ADMINISTRATIVE SHORT PLAT REPORT & DECISION

REPORT DATE:	December 4, 2014
Project Name:	Cascade Greens Short Plat
Project Number:	LUA14-001284; SHPL-A
Project Manager:	Kris Sorensen, Associate Planner
Owner:	Timothy and Elizabeth Zwicker; 11427 SE 162 nd St; Renton WA 98055
Applicant/Contact:	Kristen Harris; 10945 SE 168 th St; Renton WA 98055
Project Location:	11427 SE 162 nd St; Renton WA 98055
Project Summary:	The applicant is requesting Administrative Short Plat review of a 29,774 square foot lot (PID 088000260) in the Residential-8 dwelling units per acre (R-8) zone to be subdivided into four single-family residential lots. The subject property is located east of 114 th Ave SE along SE 162 nd St. The density would be 7.5 dwelling units per acre. Vehicular access to the lots would be from SE 162 nd St utilizing a shared private driveway in a 20-foot wide access easement located on the eastern property boundary. Proposed lot sizes range from 5,067 sf to 12,962 sf in size. No sensitive areas or special features are located on the proposed project site. Eight trees are proposed to be retained. The existing home would be retained. A drainage technical information report was provid

SHEET TITLE:
 SHORT PLAT PLAN
 PLAT PLAN
 SHEET NO.: 1

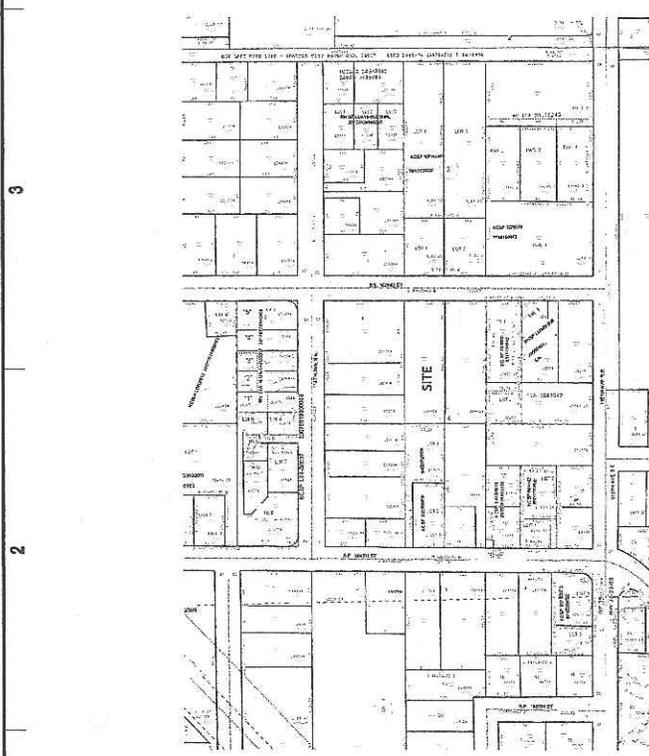
1. The applicant shall provide an updated Short Plat plan that provides for the required 5-foot setback between the existing home and the proposed 20-foot wide shared driveway. The Short Plat plan shall be provided to the Current Planning Project Manager for review and approval prior to construction permit issuance. If the setback cannot be met by a revision to the driveway, the Short Plat would not be approved without demolition of the structure or parts of the structure that would bring the home into compliance with the required 5 foot setback.

7. The applicant shall provide a revised short plat plan identifying compliance with the shared driveway standards and emergency access standards, including but not limited to the minimum 5 foot separation from the property line and the 20 foot width. Such plan shall clearly identify the easement location on all proposed lots. The revised plan shall be submitted for review and approval to the Current Planning Project Manager prior to construction permit issuance.

Two of the short plat drawing submittals note the short plat name as "ZWICKER", while the Land Use Permit Master Application calls said subdivision "Cascade Greens". Note the correct name on all future drawing submittals.

Remove the zoning and density information from the "SITE STATISTICS" block currently shown on the "ZWICKER SHORT PLAT" submittal.

Remove the setback lines shown on Lots 2, 3 and 4. Setbacks are determined when permits are issued.

EXHIBIT 15

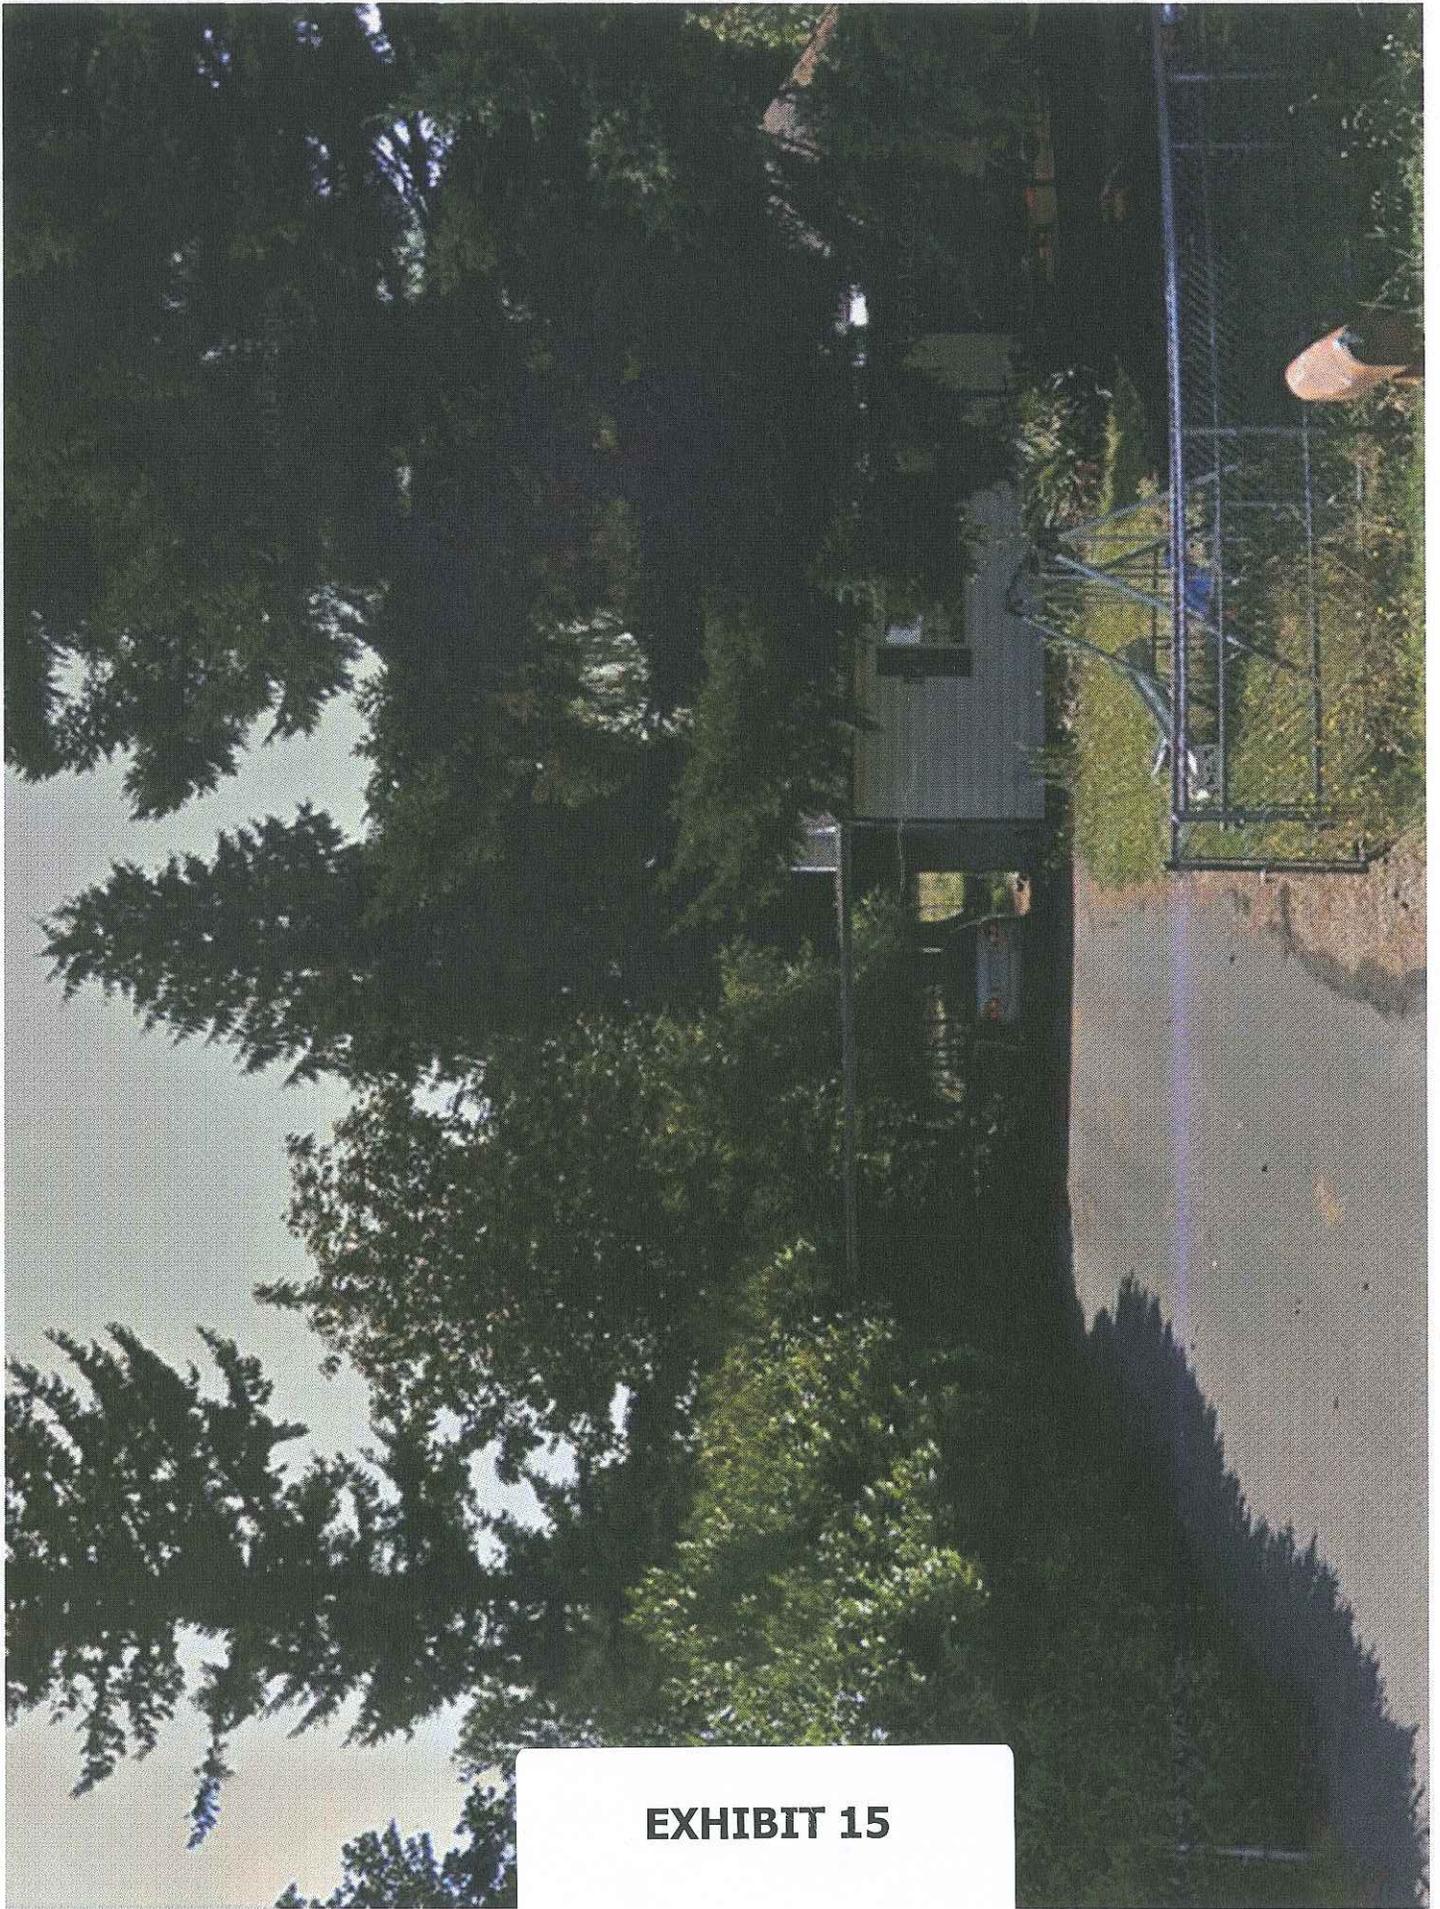
9. All lots shall take access from the proposed shared driveway. A note to this effect shall be recorded on the face of the short plat.
10. The applicant shall remove the carport on the east side of the existing home where the private driveway is to be located and to provide for the required setback between the existing home and driveway. The carport shall be demolished and documentation of such demolition shall be provided to the Current Planning Project Manager prior to recording of the short plat.
